Washington State Department of Transportation I-405, Brickyard to SR 527 Improvement Project Contract No. 009727	Doc Type: RFI
		REV#: 0
		SPEC SECTION:
		DATE: 12/11/2024
		CRE #: BY-CRE-01613

To: Washington State Dept. of Transportation 18911 N Creek Pkwy S Suite 150 Bothell, WA 98011	From: Skanska USA Civil West 1995 Agua Mansa Road Riverside, CA 92509
Submittal: BY-CRE-01613_009727_RFI_00265_16.03.02_MSE Wall 23.80R Settlement and Plumbness

Subcontractor/Supplier: Skanska
SKA Title and Description: MSE Wall 23.80R Settlement and Plumbness Due Date: 12/13/2024

GROUND IMPROVEMENTS AT WALL 23.80 11+50 - 14+50	Hz Scale 1:20
Drawn By: R.BARTON	Sheet No: 1 / 1
File Ref: SR0421.vce

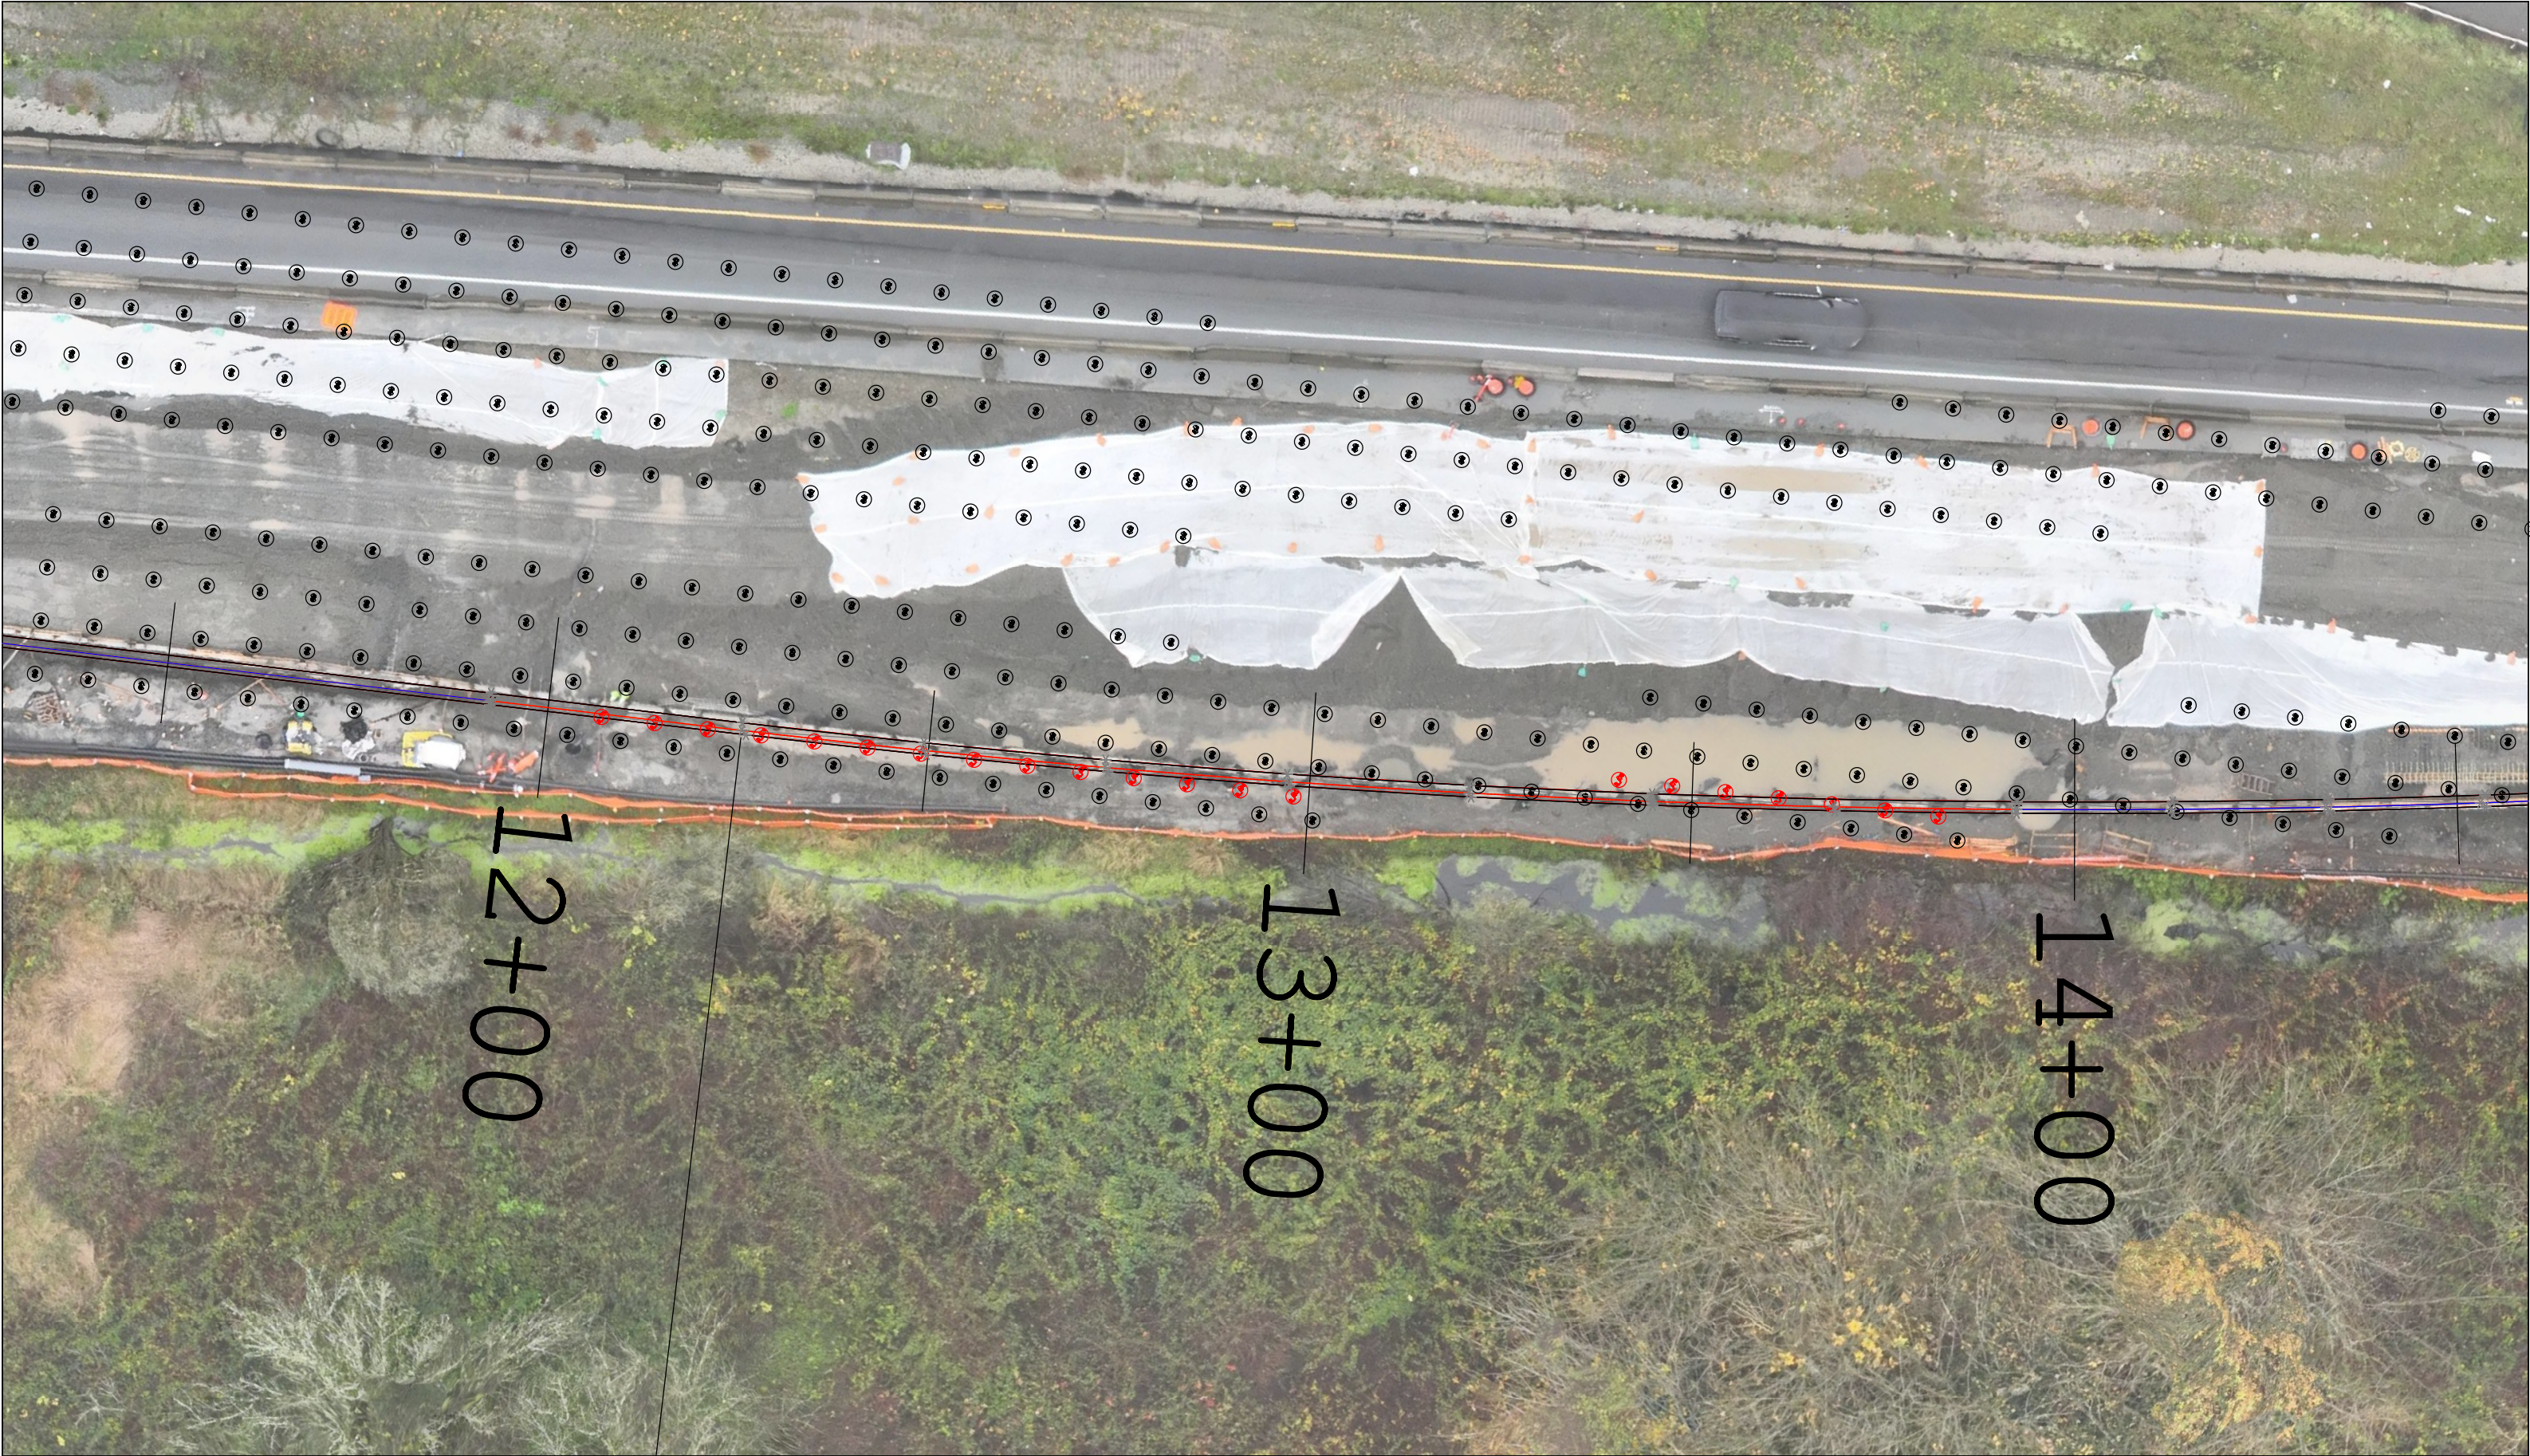
Drawing W22-6 Detail 2 provides a reinforced concrete leveling pad for Wall 23.80R.

In accordance with Drawing W22-6 and Segment 2 Package 1B Geotech RFC Section 6.4.4.2, Skanska constructed a reinforced concrete leveling pad for Wall 23.80R without a load transfer pad above the stone columns. Skanska then began setting MSE panels and backfill.

On 10/31/24, Skanska observed that the MSE wall facing panels installed on Wall 23.80R from approximately STA 12+00 to 15+00 had positive batter in excess of 5 inches at the top of panels. On 11/6/24, Skanska began removing backfill and MSE panels for reinstallation to achieve the required plumbness and wall line. On 11/7/24, one day after resetting a portion of the MSE panels and beginning the backfill operation in accordance with the wall designer's installation manual, Skanska observed panels that had been reset had gained 1"-2" of positive batter overnight.

Upon further investigation, Skanska confirmed that the leveling pad at wall STA 12+00, STA 12+50 and STA 13+00 has settled 0.01 feet, 0.13 feet, and 0.25 feet respectively. The observed settlement exceeds the estimated settlement listed within the geotech report Table 6.34; however, is within the allowable settlement.

Based on the observed movement of the subgrade and Wall 23.80R, Skanska is concerned that the stability of the ground conditions is impacting the plumbness of Wall 23.80R. Skanska requests the design team consider the observed movements and provide details to limit movement within allowable tolerances during construction.

Based on survey results provided by Skanska, it appears that the reinforced concrete leveling pad is settling more or less vertically (with minimal rotation of the leveling pad). Those areas appear to line up fairly well with zones where the leveling pad spans across from one row of stone columns to another (i.e. the layout of the stone columns was on a square grid and did not follow the path of the wall's leveling pad). The soil beneath the existing leveling pad may be soft enough to be settling beneath the load of the MSE wall panels. The issue appears to be concentrated underneath the deepest portion of the leveling pad from Wall Station 11+95.007 to 13+90.007 where the top of the 12" thick leveling pad is called out at elevation +22.40'.

We recommend removing the existing wall and leveling pad within the station range noted above plus a short zone to the north of station 13+90.007 and a short zone to the south of station 11+95.007 as described in greater detail below. We recommend that an over excavation and replacement of the unsuitable subgrade be performed to a depth of 3 feet below the bottom of the proposed new concrete leveling pad. We recommend that this over excavation (at 3' below the bottom of the proposed new concrete leveling pad) should extend at that elevation at least between wall station 11+92.007 and 13+93.007. We recommend that the ends of the over excavated trench can then be sloped up from there to existing wall footing grade at a slope no steeper than 1H:1V to help ease the transition between the deepest portion of the leveling pad (i.e. top of leveling pad elevation +22.40') and the portions to the south and north of it where the leveling pad is planned at a higher elevation. We recommend that the over excavated trench below the leveling pad be a minimum of 6' wide and extend horizontally at least 2' from the planned wall panel face toward the east (i.e. toward the existing creek) and extend horizontally at least 4' from the planned wall panel face toward the west (i.e. toward the reinforced backfill zone under the roadway).

We recommend that one of two options (or a combination of both) be utilized to backfill the over excavated area.

Option 1: Place a layer of Mirafi 160N geotextile separation fabric (or equivalent) down in the over excavated trench and backfill over the top of it with 12" of compacted Gravel Borrow (9-03.14(1)) or Gravel Borrow for Structural Earth Wall (9-03.14(4)) compacted in accordance with WSDOT Standard Specifications 2-03.3(14)C - Method B. Place a layer of Tensar BX1500 geogrid on top of the first 12" thick compacted layer of gravel and place a second 12" thick layer of compacted Gravel Borrow (9-03.14(1)) or Gravel Borrow for Structural Earth Wall (9-03.14(4)) compacted in accordance with WSDOT Standard Specifications 2-03.3(14)C - Method B. Place a second layer of Tensar BX1500 geogrid on top of the second 12" thick compacted layer of gravel and then place a third and final 12" thick layer of compacted Gravel Borrow (9-03.14(1)) or Gravel Borrow for Structural Earth Wall (9-03.14(4)) compacted in accordance with WSDOT Standard Specifications 2-03.3(14)C - Method B. Either a reinforced concrete leveling pad (in accordance with the existing wall plans) or an unreinforced concrete leveling pad (in accordance with the pre-approved plans for SSL walls described in the WSDOT GDM Chapter 15, Appendix 15-N), can be constructed on top of the backfill section described above.

Option 2: Backfill the trench with unreinforced controlled density fill (cdf). Either a reinforced concrete leveling pad (in accordance with the existing wall plans) or an unreinforced concrete leveling pad (in accordance with the pre-approved plans for SSL walls described in the WSDOT GDM Chapter 15, Appendix 15-N), can be constructed on top of the backfill section described above.

We recommend that either backfill option described above can be used, or a combination of both where conditions and space are best suited to either method. If both methods are used along the length of the trench, the swap from one to another can occur at a vertical plane or at a sloping transition with either method on the top or bottom of the slope.

As the Geotechnical Special Inspector (GSI) and in accordance with RFP Section 2.6.8.2.1, a representative from GeoEngineers should be called out to the site to perform geotechnical special inspections in the field for all segments of the over excavated trench before backfilling activities begin to occur in that given segment. GeoEngineers should also be called out to the site to perform geotechnical special inspections in the field for all segments of the backfilled trench once backfilling activities in that given segment are complete and before the new concrete leveling pad is poured.
